SERVICE BULLETIN

No. 300-2-95

Subject: Inspection of upper longeron at the horizontal stabilizer attachment.

Figure 1: Possible crack locations in typical horizontal stabilizer attachments area.

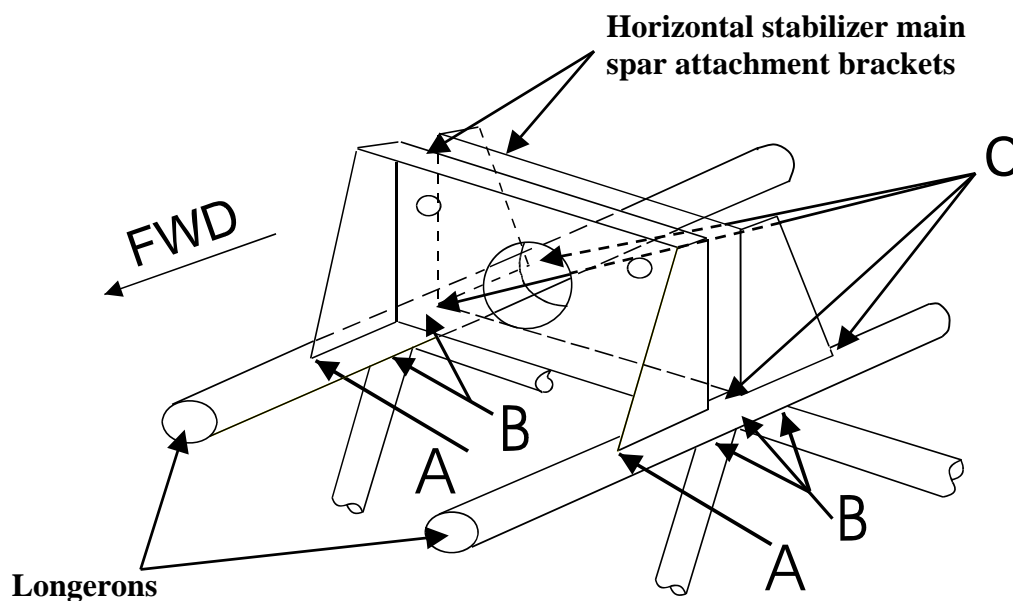
- Remove tail fairing, rudder, vertical stabilizer, elevator, and horizontal stabilizer (see Chapter 27 and 55 of the Service Manual).
- Remove fabric from fuselage upper longeron in areas A, B and C as shown in Figure 1.
- Visually inspect these areas for potential cracks, particularly at welds.
- In case of doubt remove paint and use a dye check penetrant.
- If cracks are found proceed with the instructions of Part II.
- In case no cracks are found repaint tubing as required and reglue fabric. Reassemble the empennage according Chapters 27 and 55 of the Service Manual.
- Make appropriate logbook entry of compliance with the repetitive inspection according PART I of this Service Bulletin.

Figure 2: Typical installation of split tubes to repair crack in longeron.

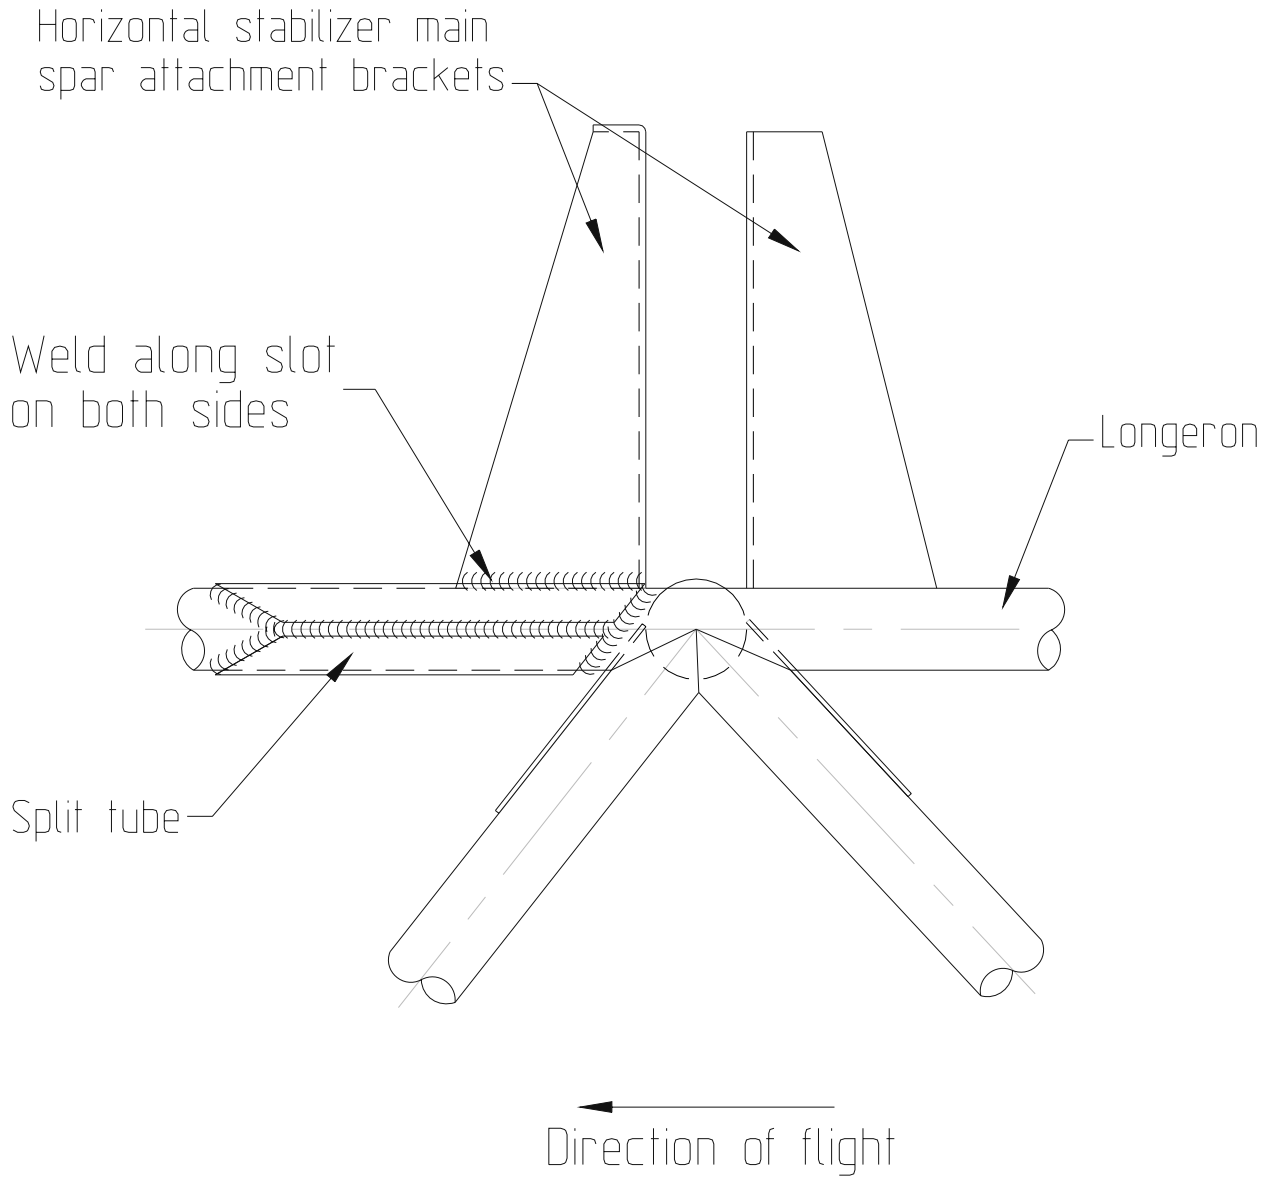
- Weld any crack in areas A, B and C. Cracks in the longerons have to be repaired with sleeves (split tubes) according Figure 2, additionally.
- Prepare parts according applicable kit (see material allowance) and Figure 3 for welding. When split tubes are installed the contours of the reinforcement steel patch plate and the related gussets have to be adjusted slightly to match their surrounding structure.

Figure 3: Typical installation of reinforcements in area around horizontal stabilizer main spar attachment brackets (view on left side).

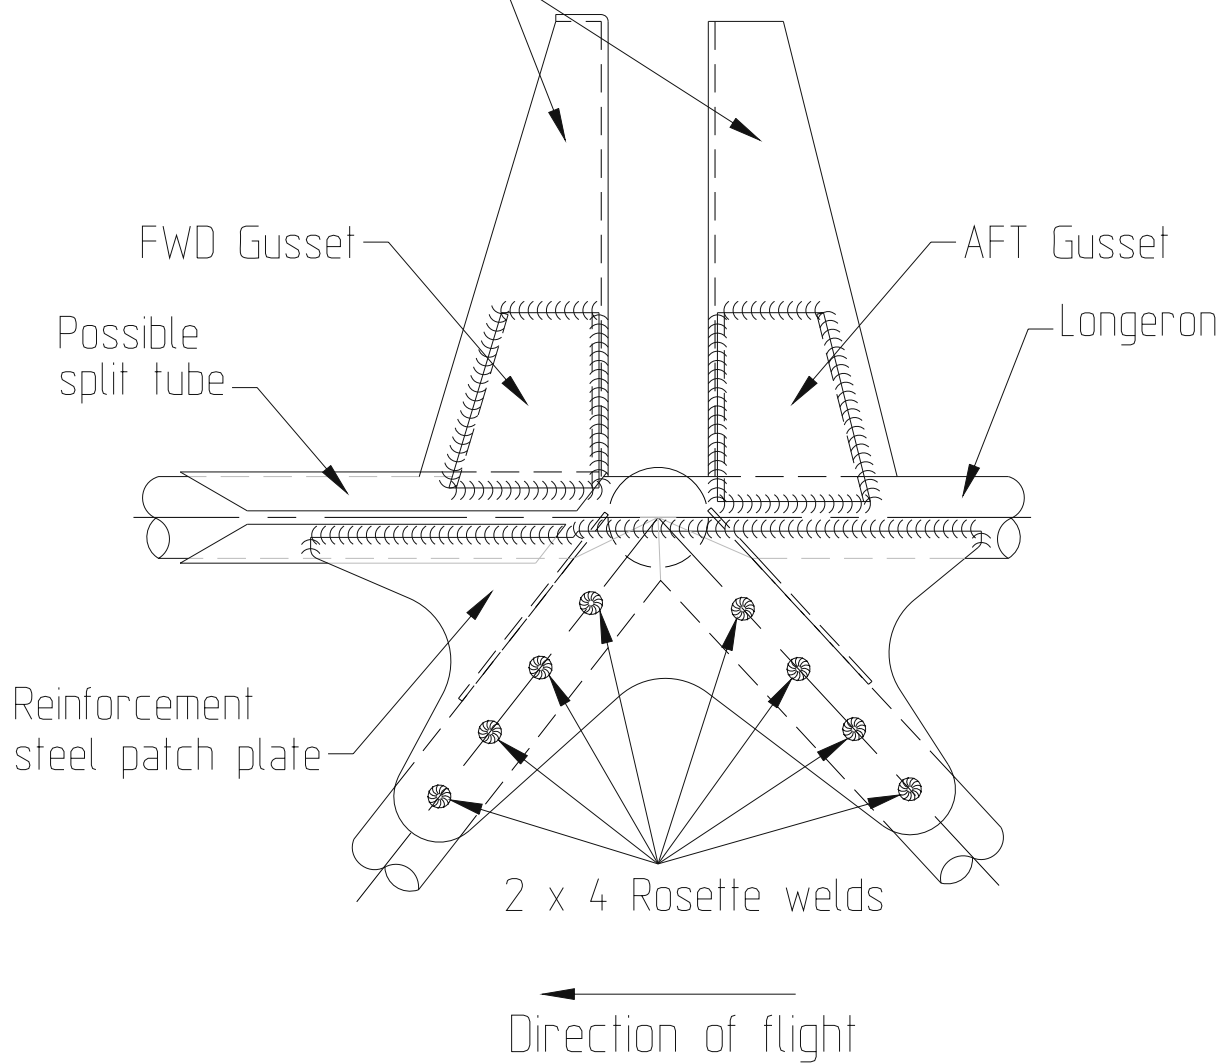
- Weld parts in place according Figure 3.
- Remove bushings and check for welding shrinkage.
- Reinstall horizontal and vertical stabilizer and check proper alignment of tail surfaces with respect to the wing. Remove stabilizers again.

Figure 4: Additional V-tubes in EA 300/S fuselage steel tube frame.

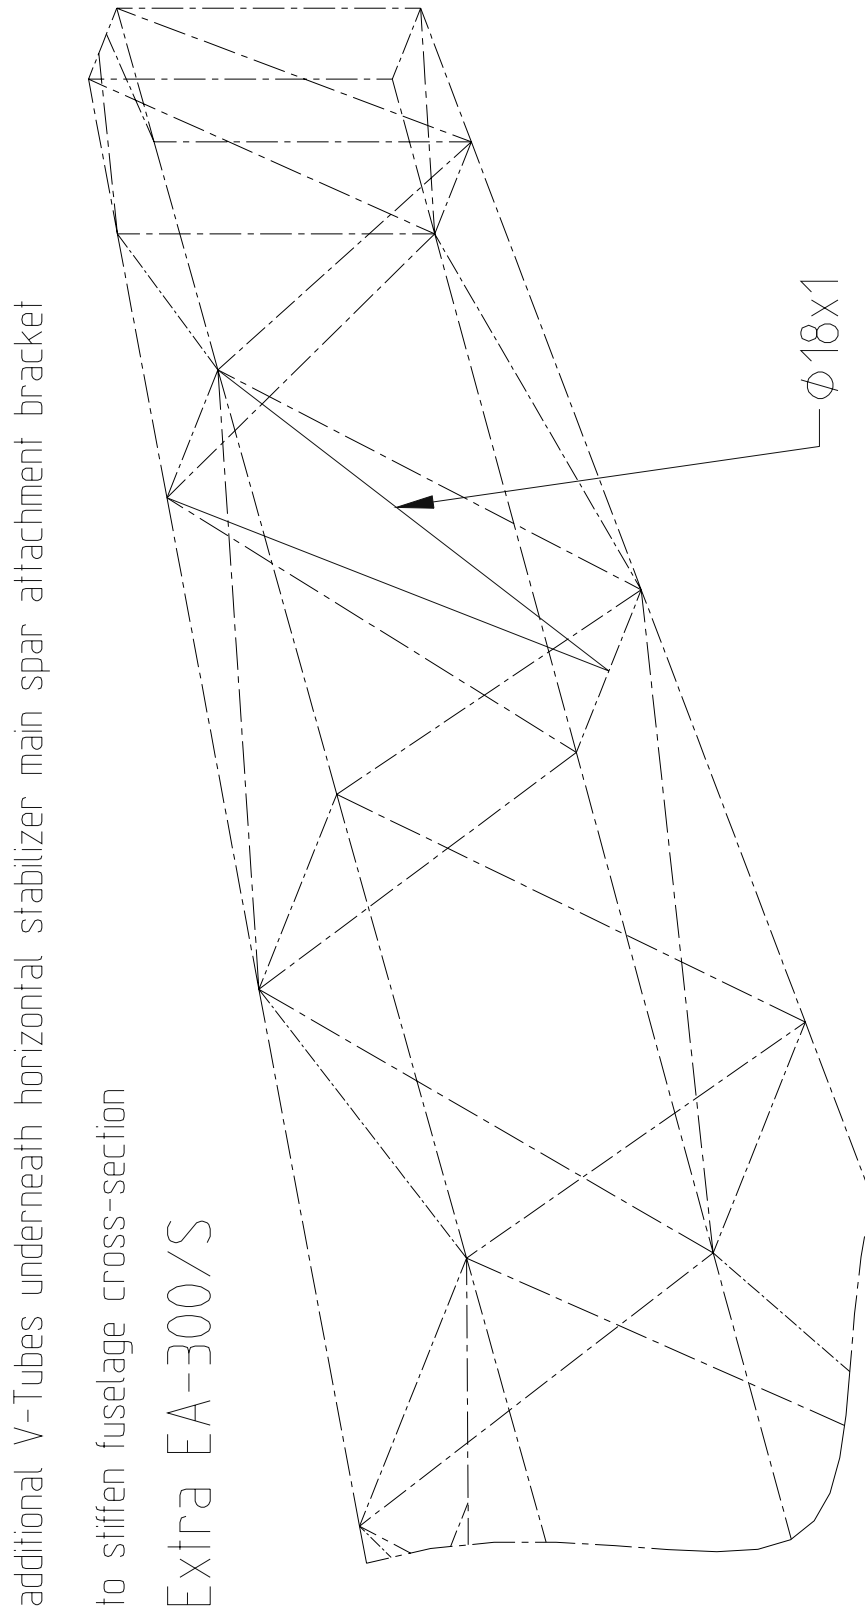
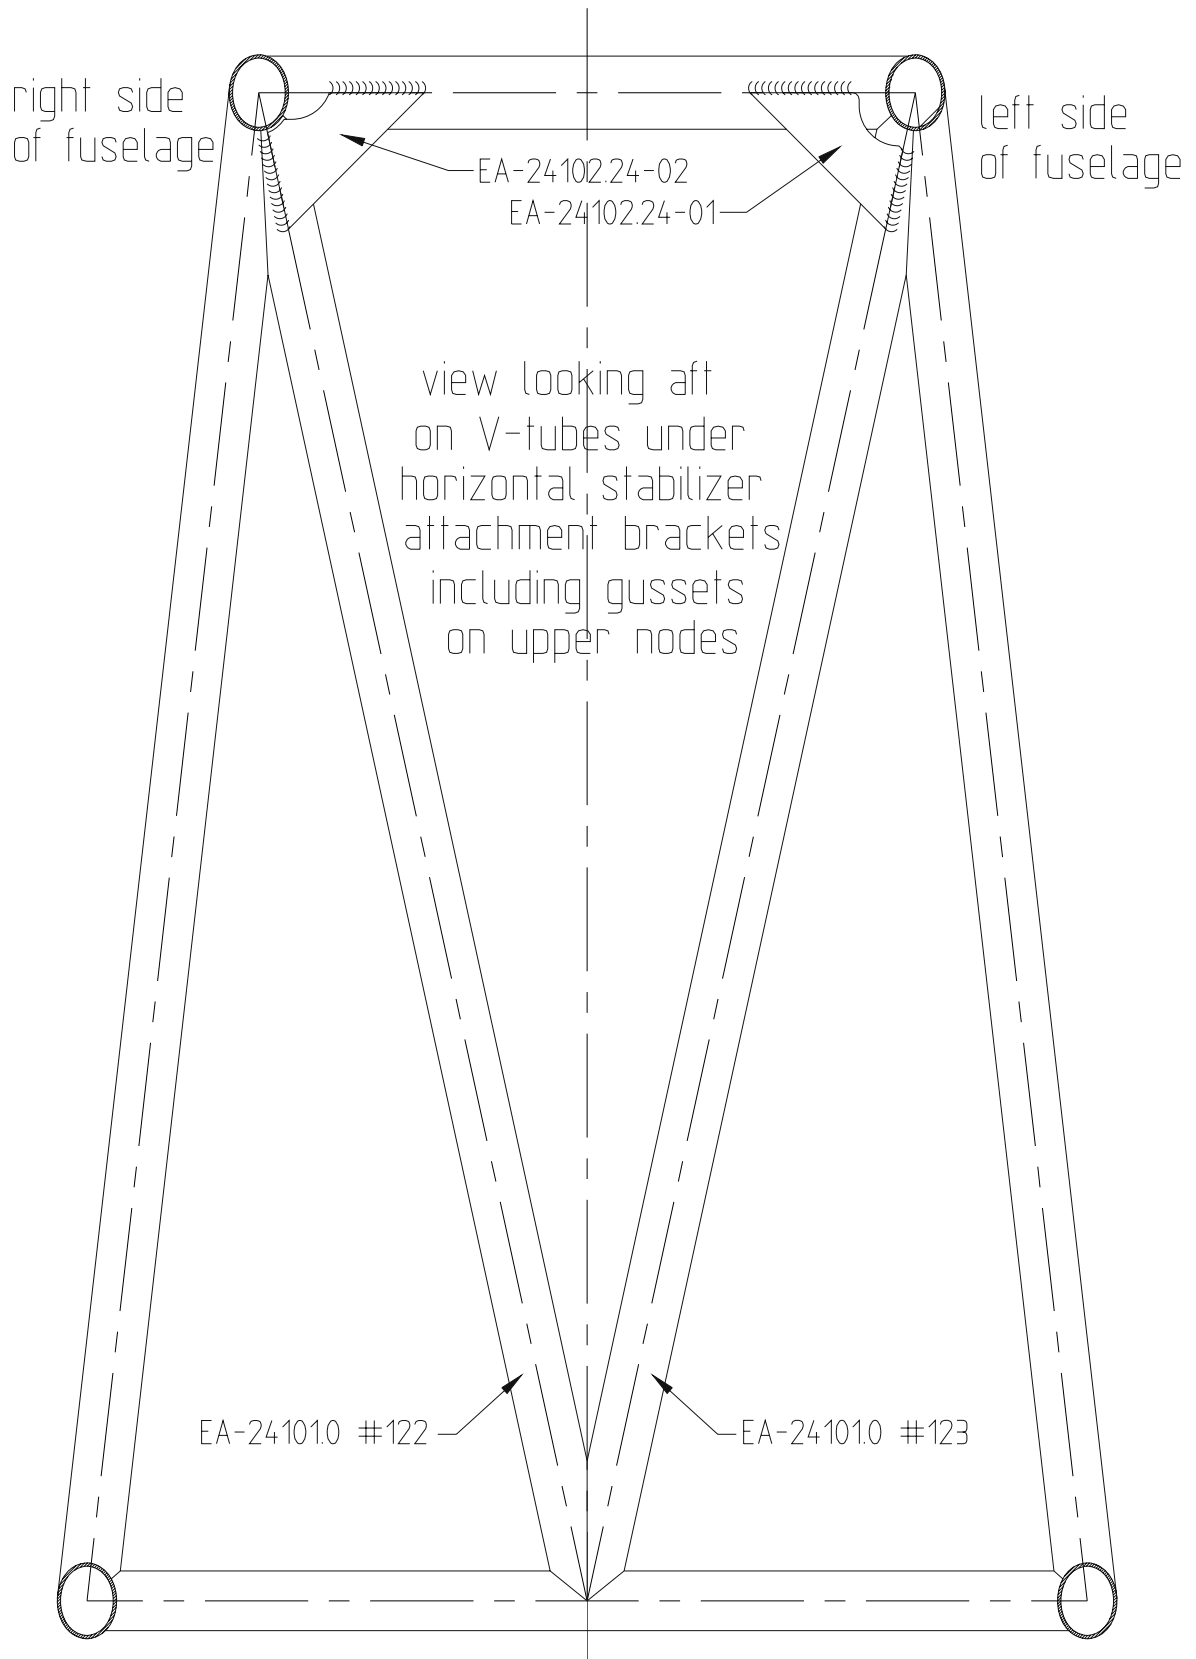
The additional V inserted into the fuselage frame underneath the horizontal stabilizer main spar attachment bracket serves the same function as a diagonal, but without interference with the elevator push-pull control. The higher stiffness of the frame against in-plane deformation minimizes local stress concentrations adjacent to the stabilizer attachment bracket reinforcements when the structure is experiencing elastic deformation under flight loads. This modification was included in the type design of the 300/S and 300/L from certain advanced serial numbers on in order to offer compatibility with an envisioned enlarged empennage with related higher tail loads.

- Make sure the V-tubes match the existing structure according to the applicable Figures (see Table 2).

- For the protection of the tube interior fill a small amount of corrosion preventive compound like ACF-50 or equivalent into each of the V-tubes.
- Weld V-tubes in place and check proper fit of gussets according to the applicable Figures (see Table 2) and weld them in place.
